City of Columbia

Municipal Planning Commission

December 8, 2021

RE: Response to Technical Review Comments
Item No. 21-0205
1451 Lasea Road
Preliminary PUD Master Plan

FIGURE 6-TRAFFIC IMPACT STUDY

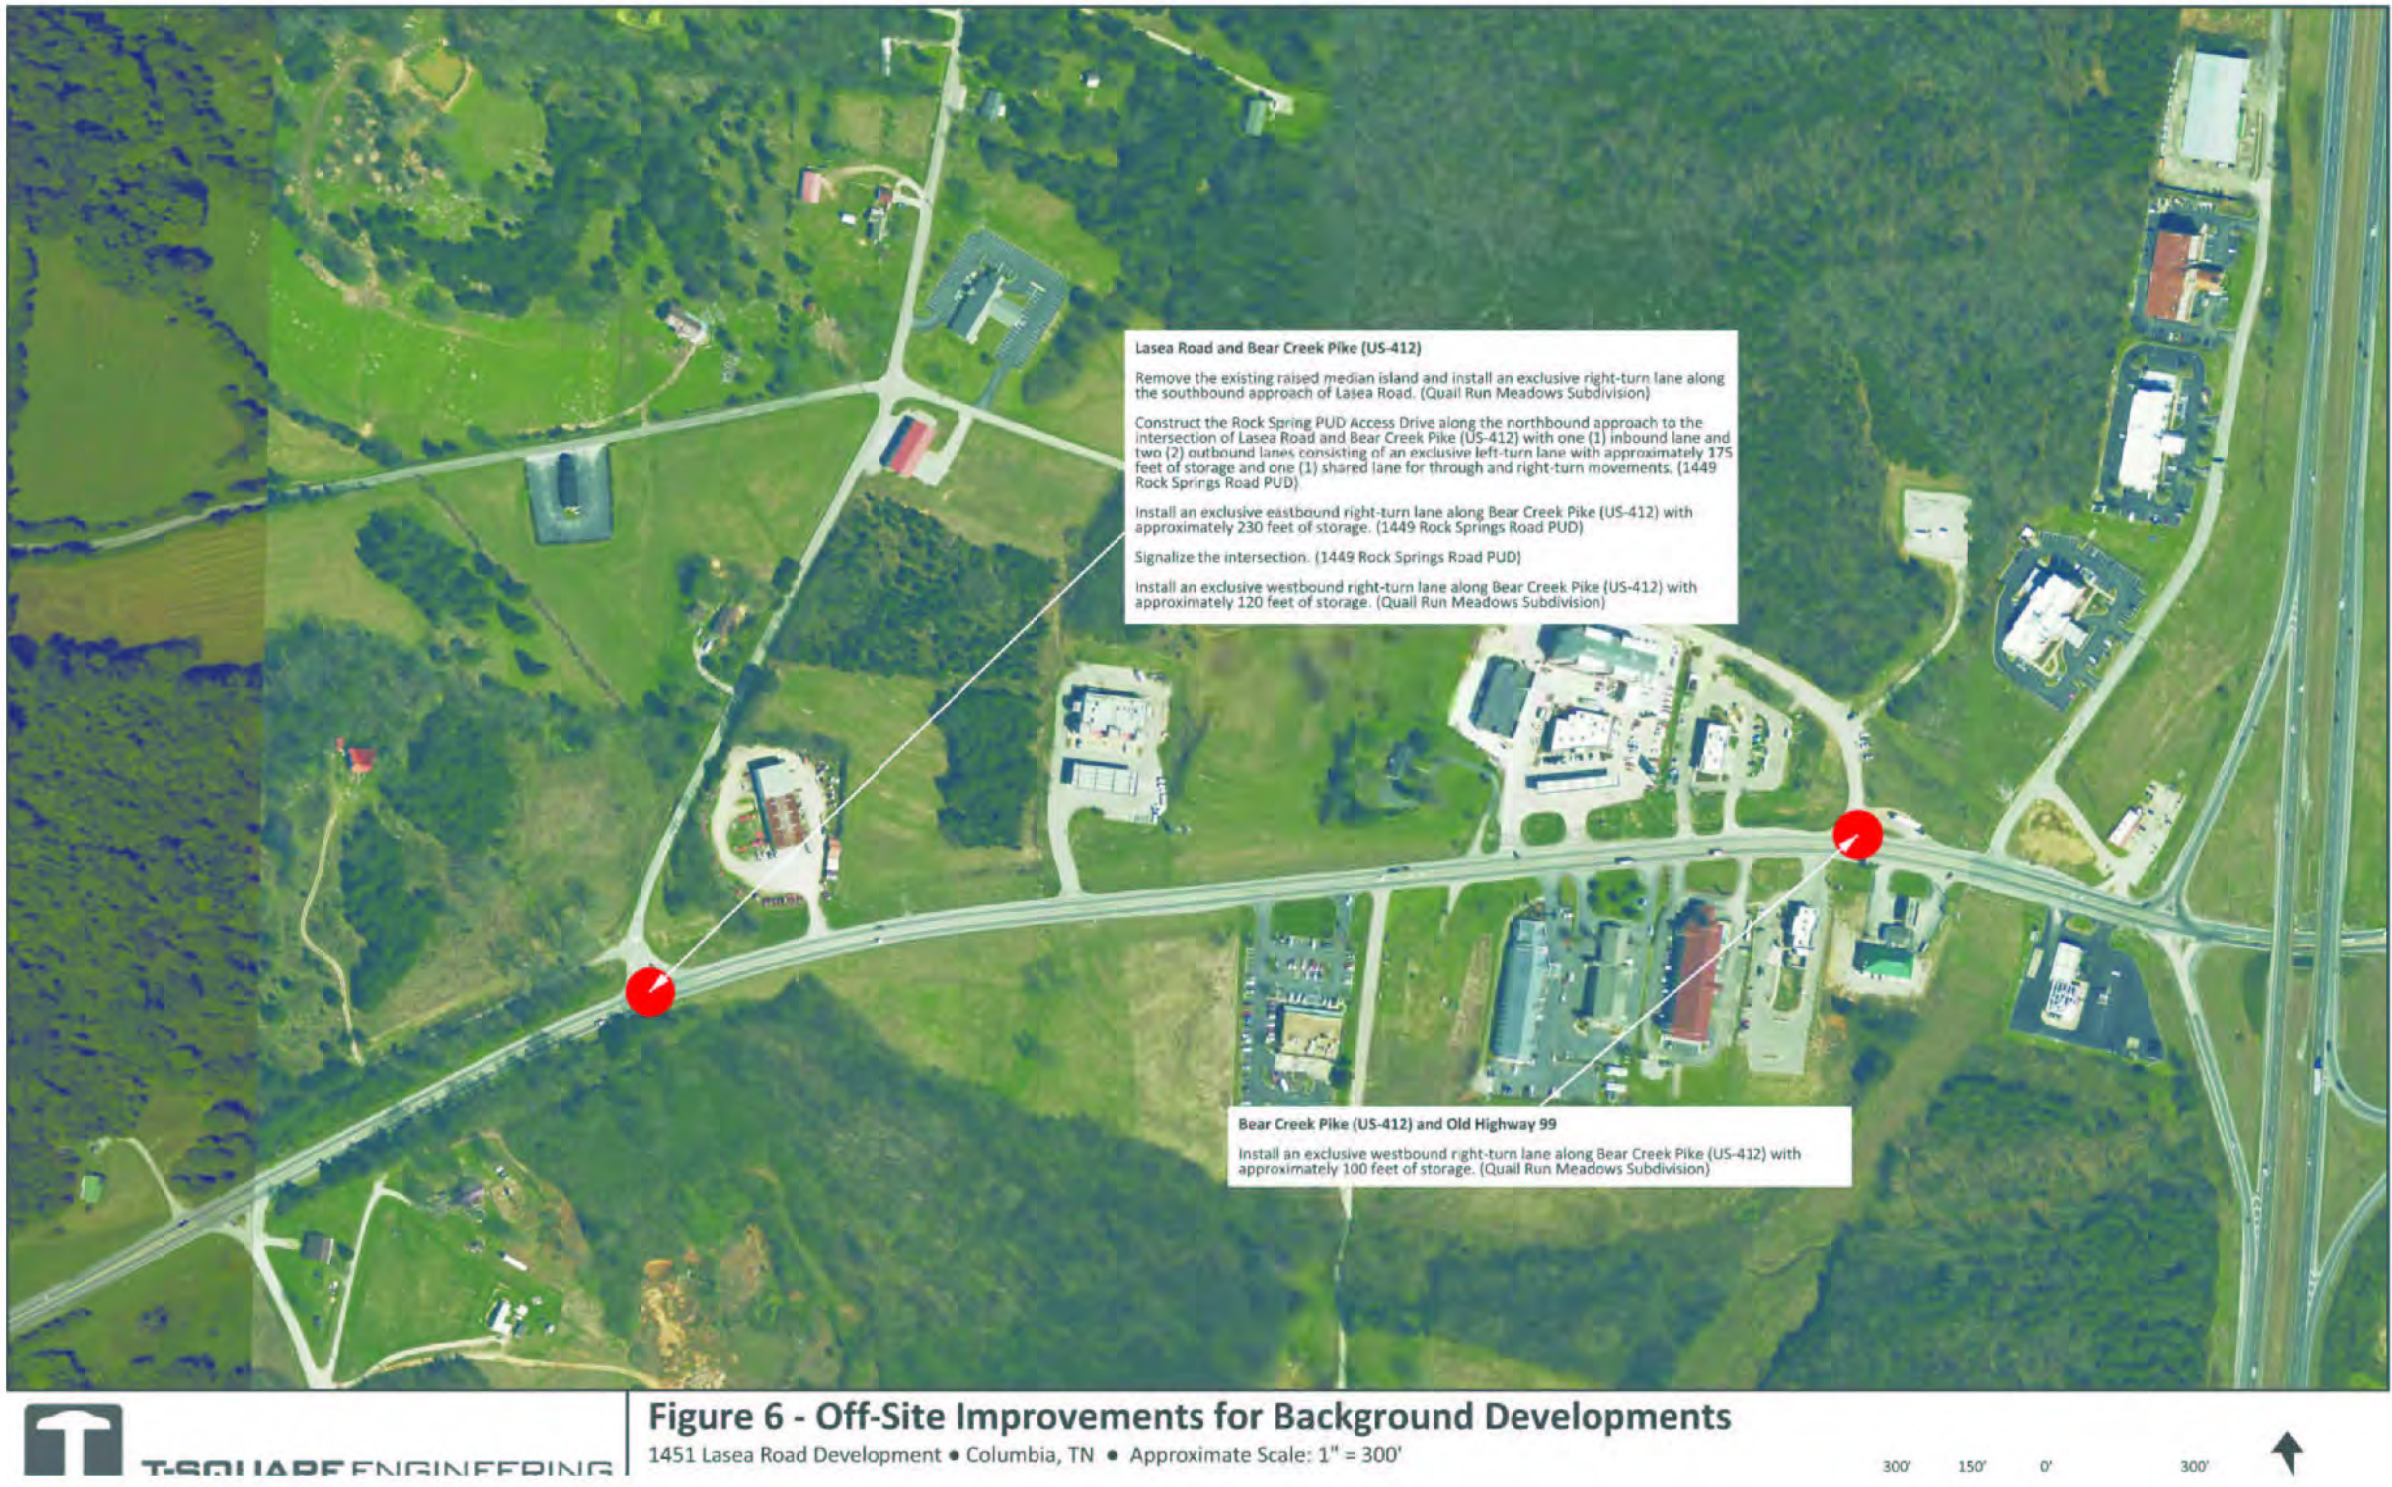
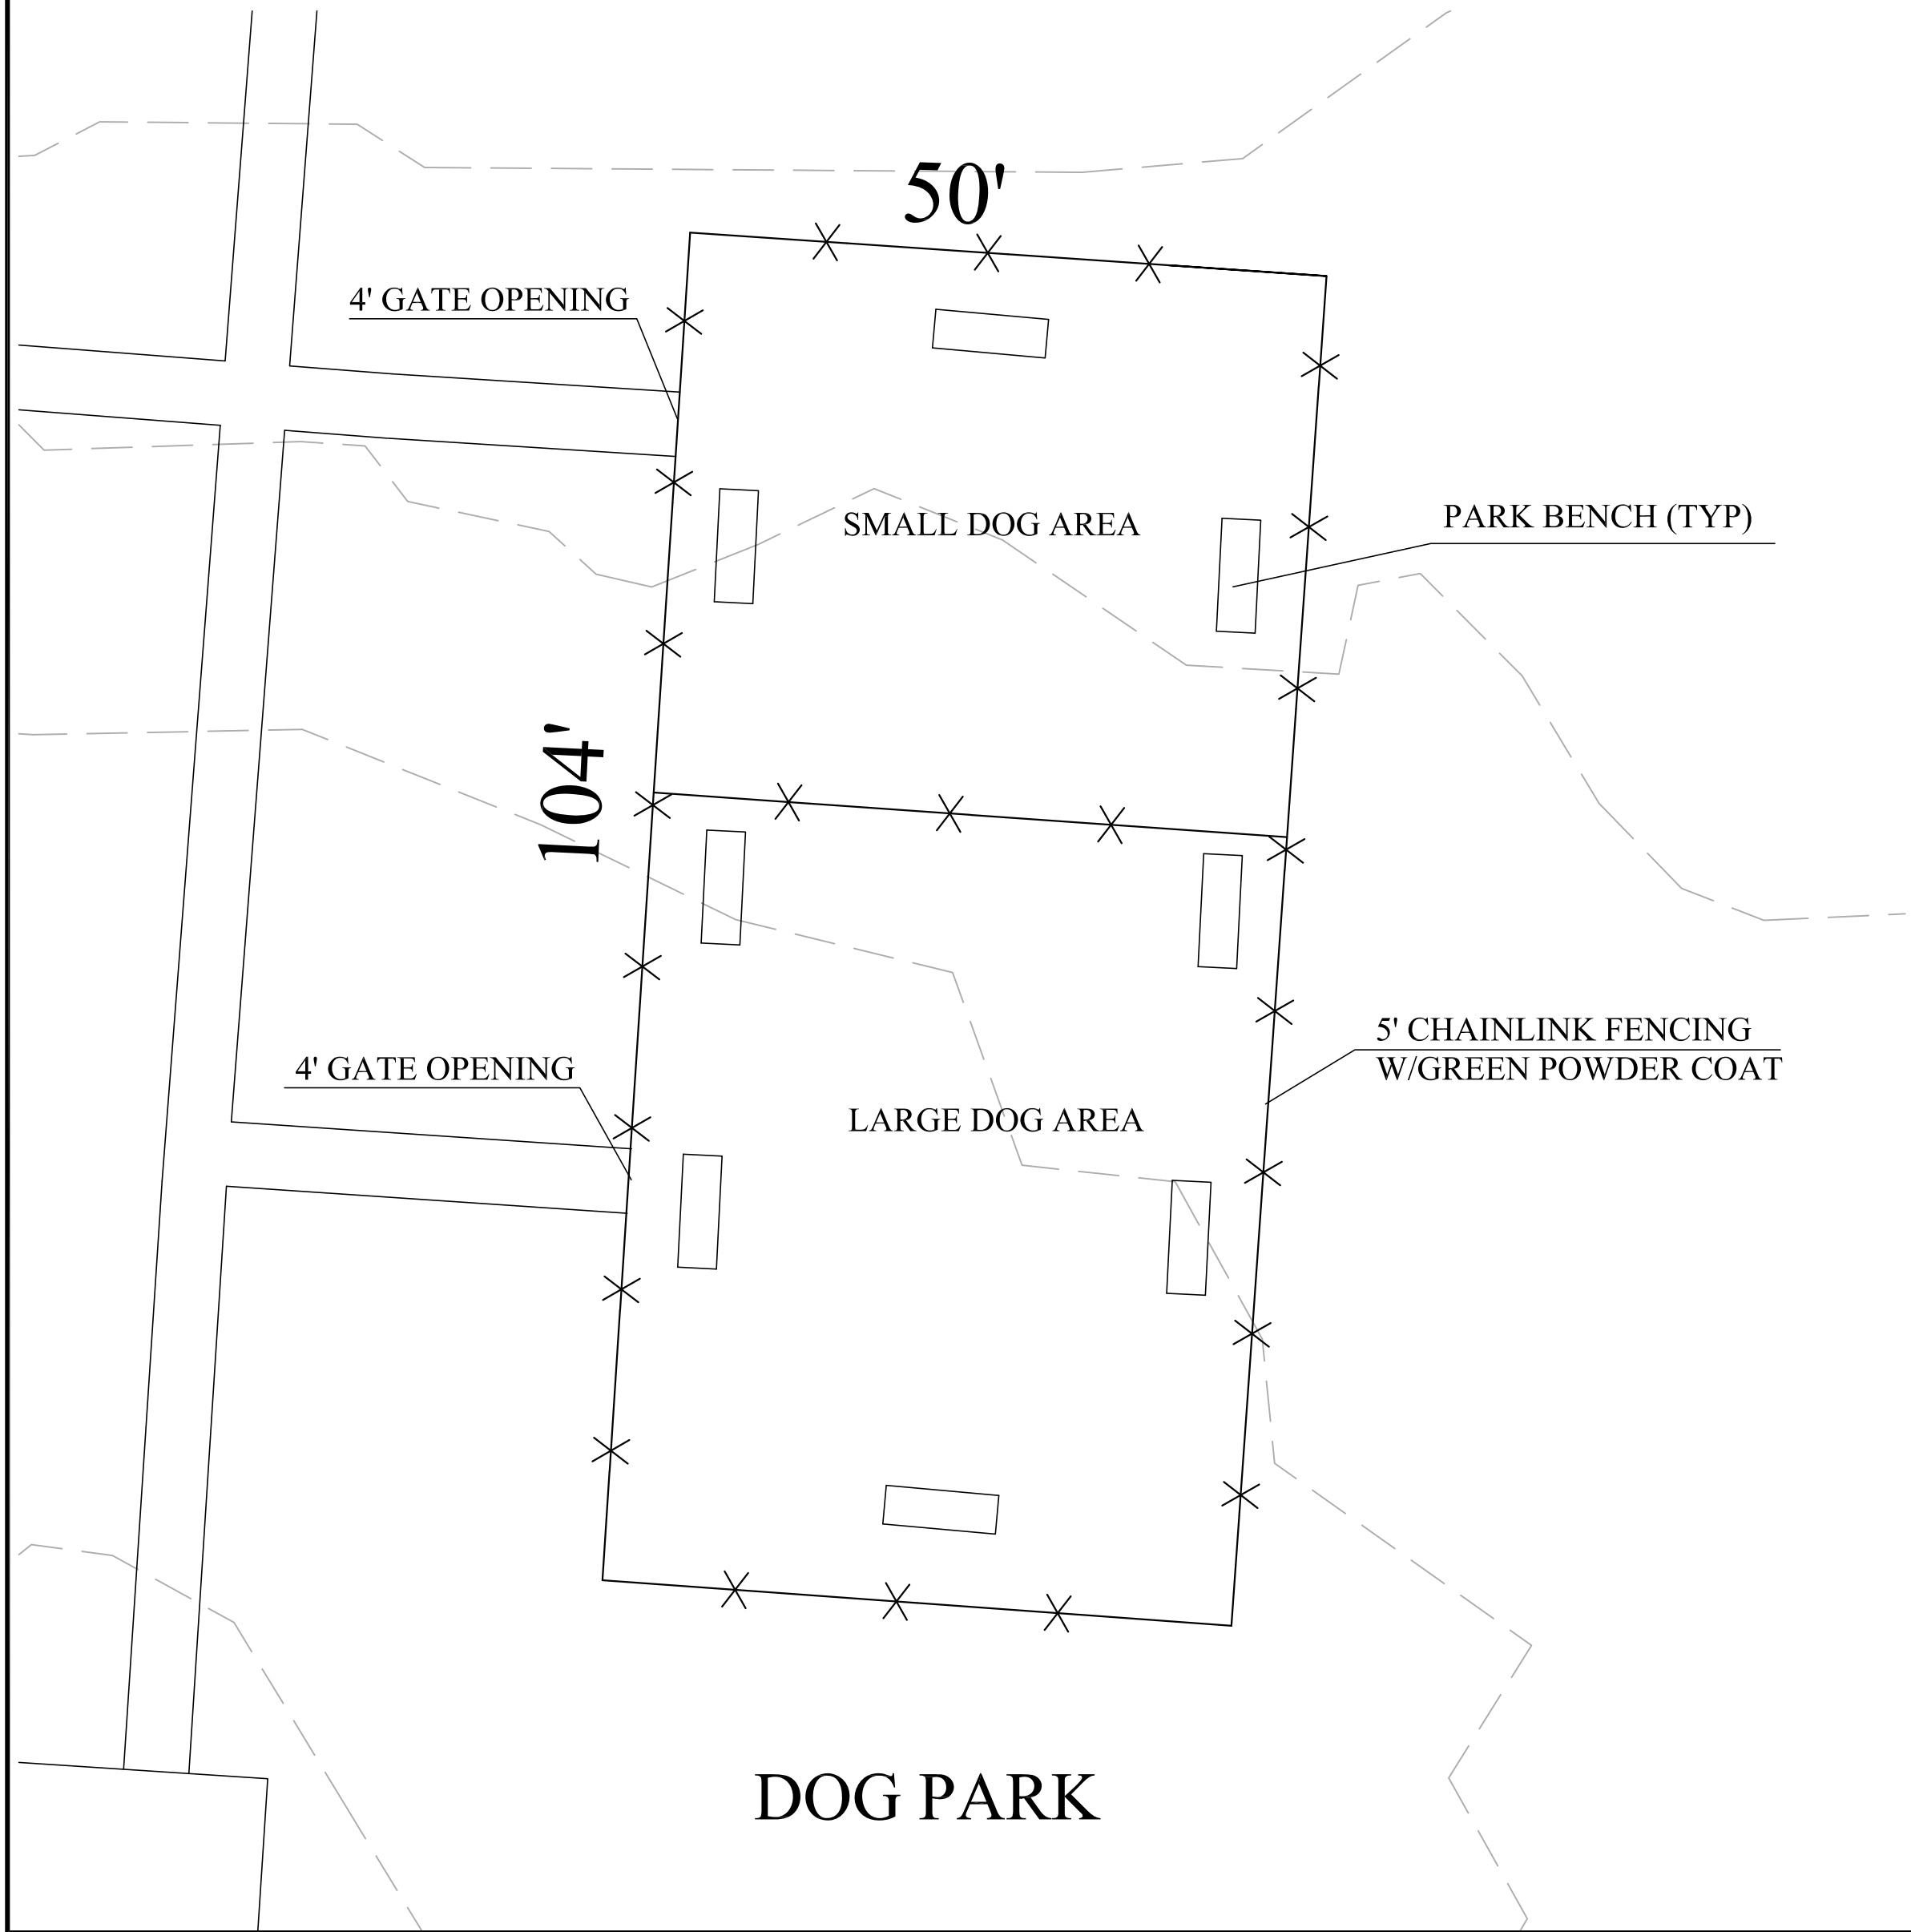
12. Subject to TIS and Construction Plans.
13. Provide figure 6 from TIS in PUD resubmittal.
14. Should any of the background developments fail to be constructed, including the off-site improvements, by the time the Lasea Townhomes are completed, the developer of the Lasea Townhomes should re-assess the off-site improvements and may be responsible for the construction of those improvements, if necessary.

12. Subject to TIS and Construction Plans. Ok
13. Provide figure 6 from TIS in PUD resubmittal. Added to detail sheet
14. Should any of the background developments fail to be constructed, including the off-site improvements, by the time the Lasea Townhomes are completed, the developer of the
